STATE OF MAINE
DEPARTMENT OF TRANSPORTATION
16 STATE HOUSE STATION
AUGUSTA, MAINE 04333-0016

January 30, 2026
Subject: Colson Bridge #2168
WIN: 025541.00
Location: **Prospect**
Amendment No. 1

COLSON BRIDGE NO. 2168
CROSSING COLSON STREAM
PROSPECT
CROSS SECTIONS

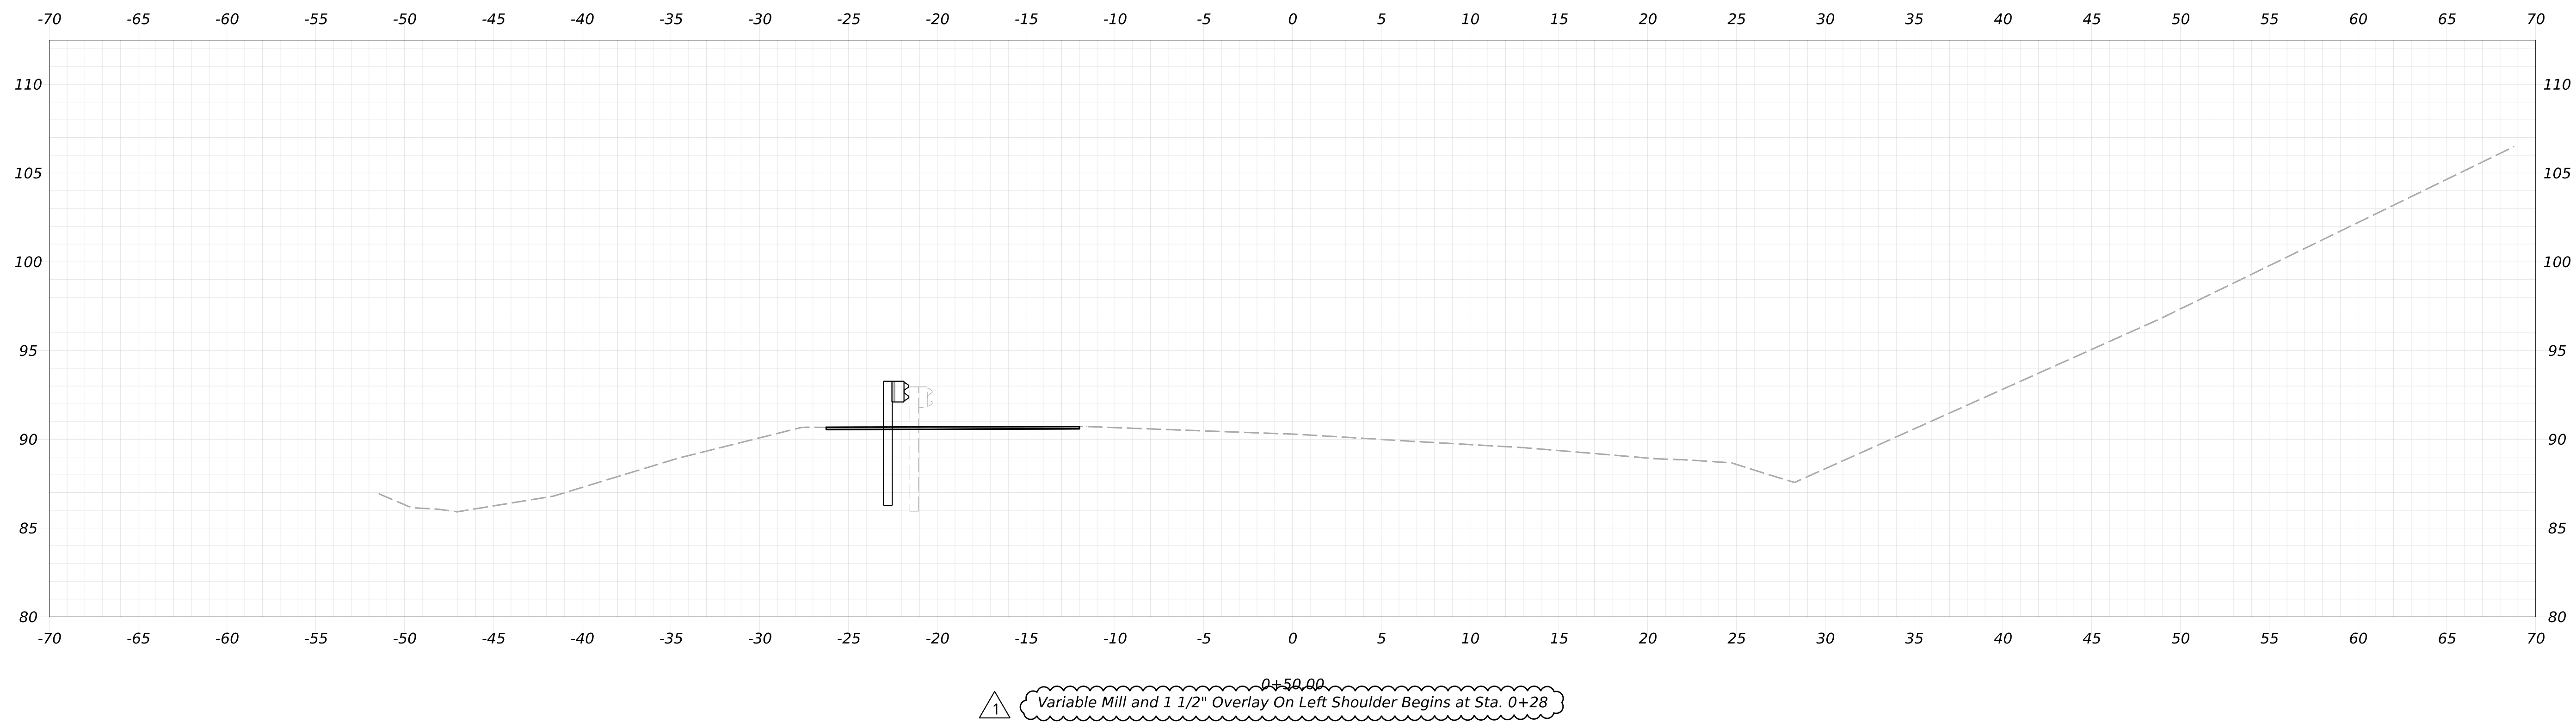
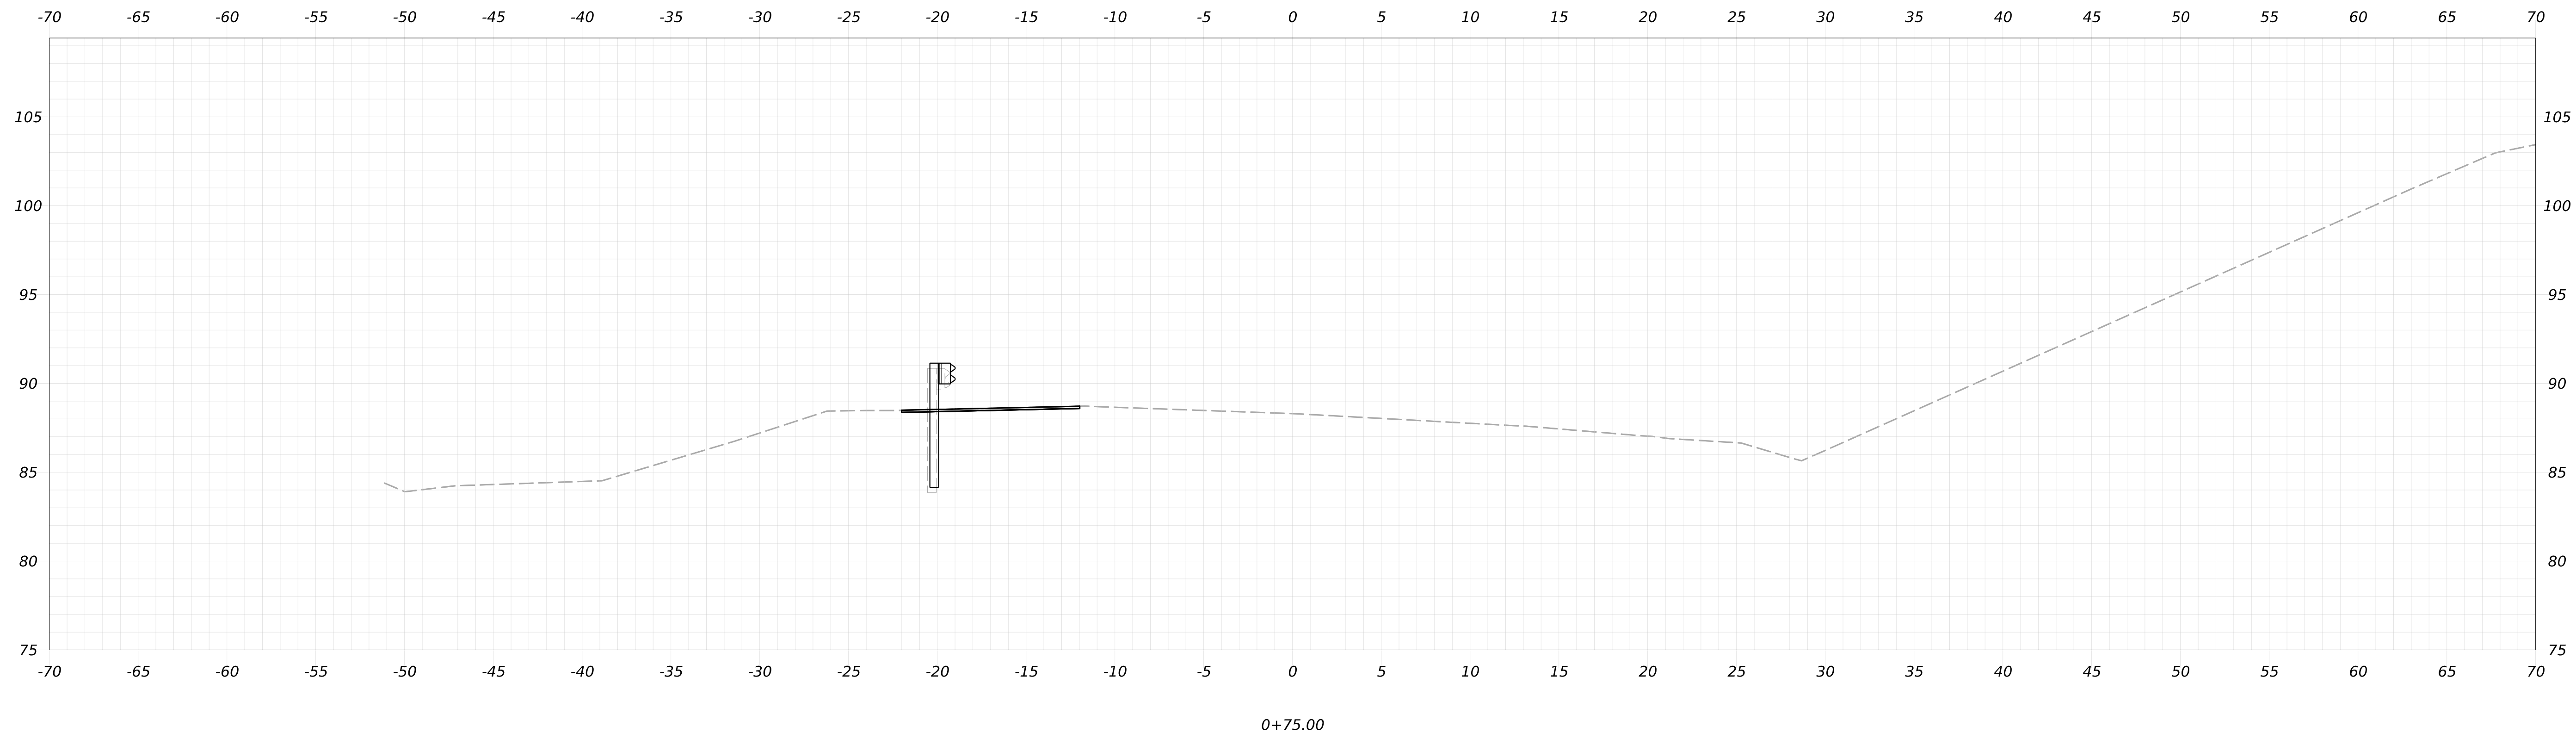
| PROJ. MANAGER | BY | DATE |
|-------------------|---|----------|
| REVISION | Update Callout on Section 0+50 to define start of Shoulder Mill and Overlay | |
